FONTHILL STATION ALIGNMENT
EXTRACT

KILDARE ROUTE PROJECT
rebuilding the railway

Extract No. 1843/001
EXTRACT FROM RWO ALIGNMENT PLAN No. 1843

APPENDIX 4

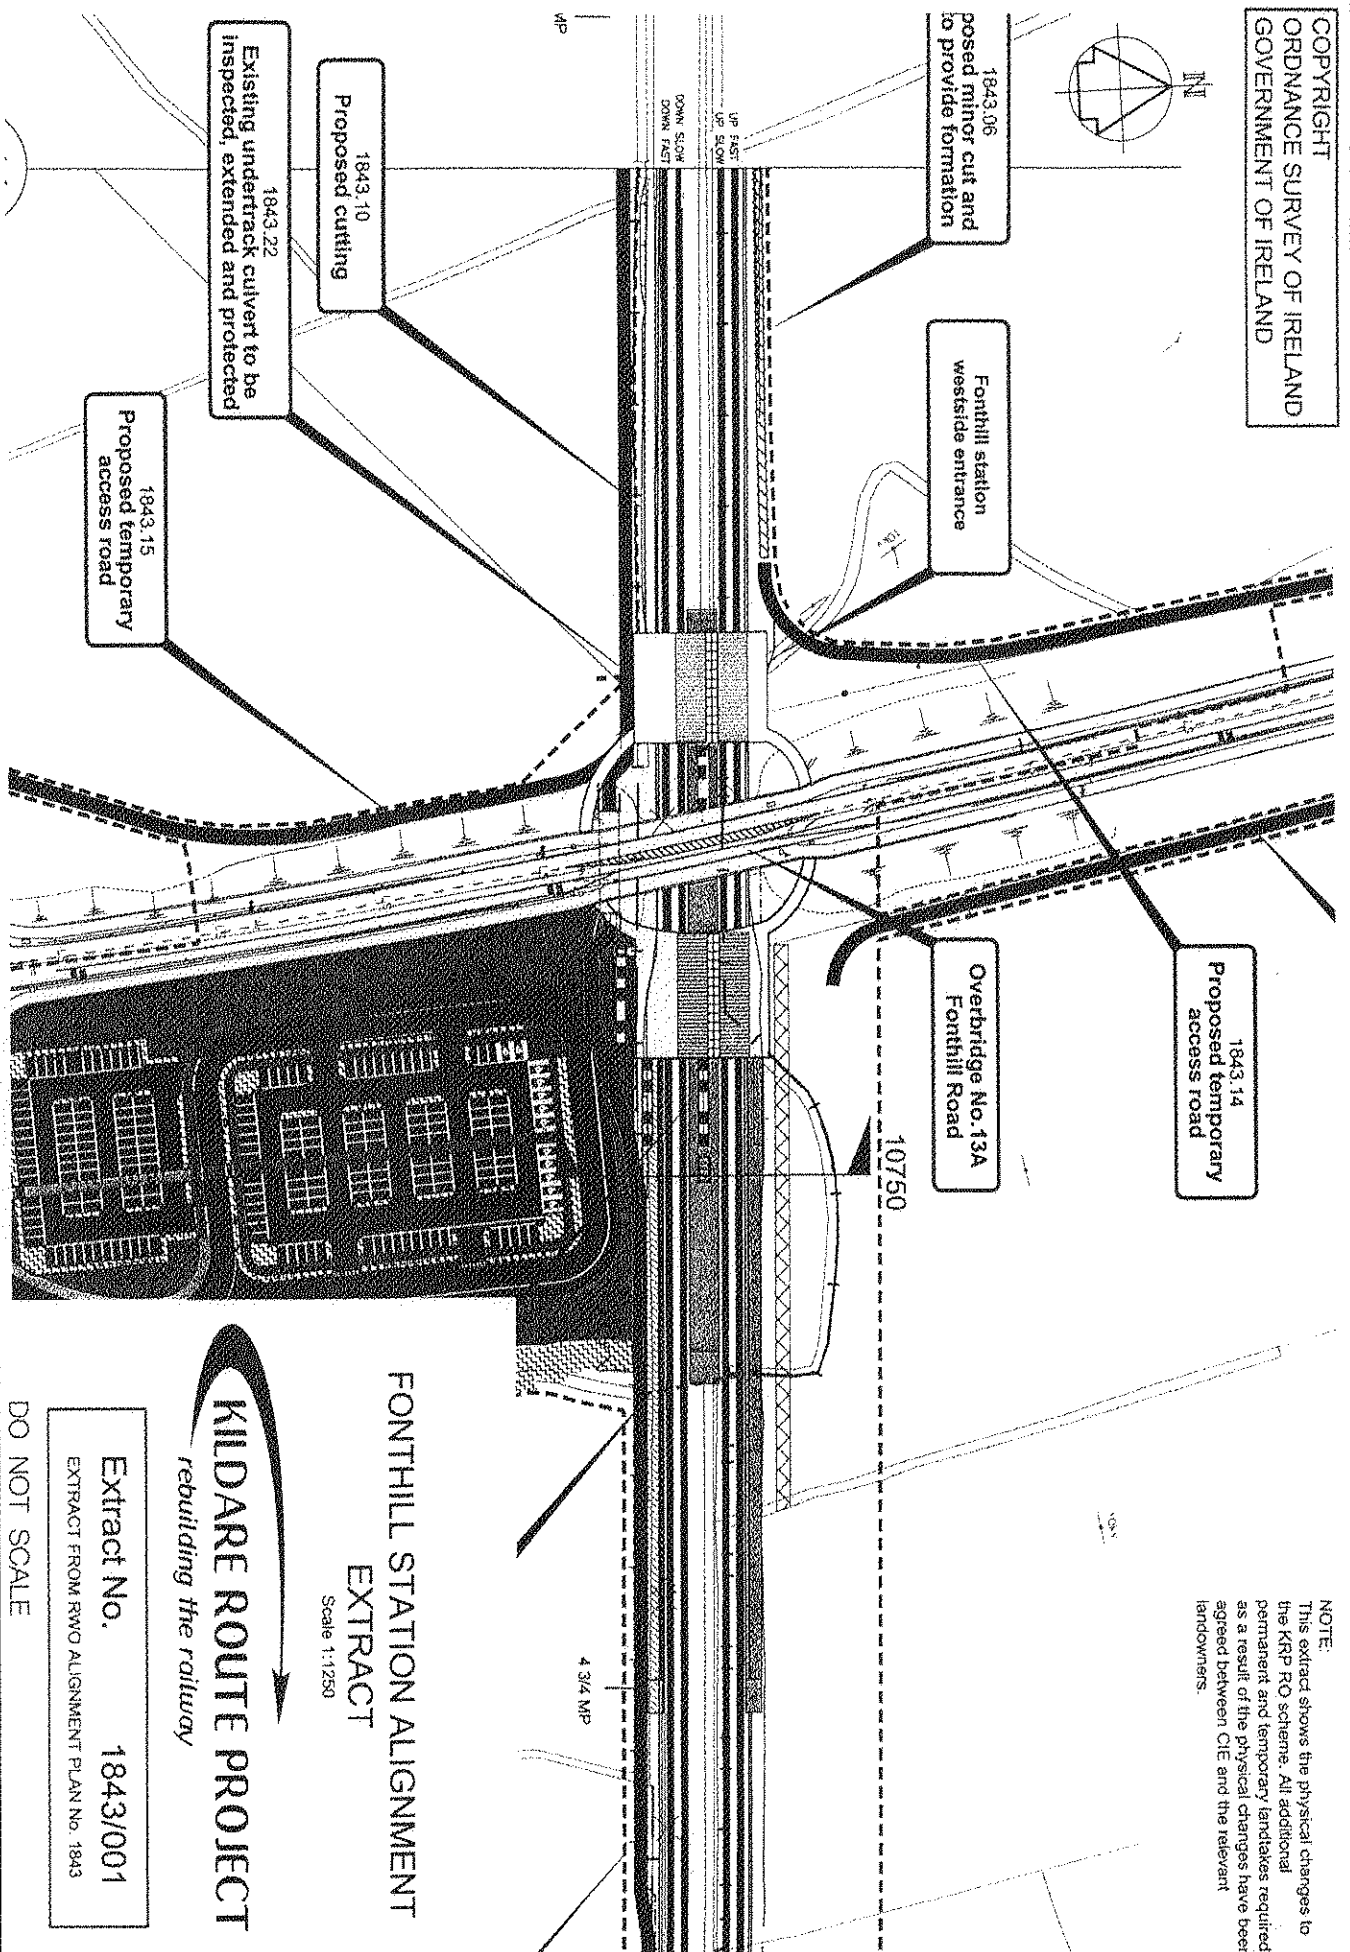
NOTE:
This extract shows the physical changes to the KRP RO scheme. All additional permanent and temporary landtakes required as a result of the physical changes have been agreed between CIE and the relevant landowners.
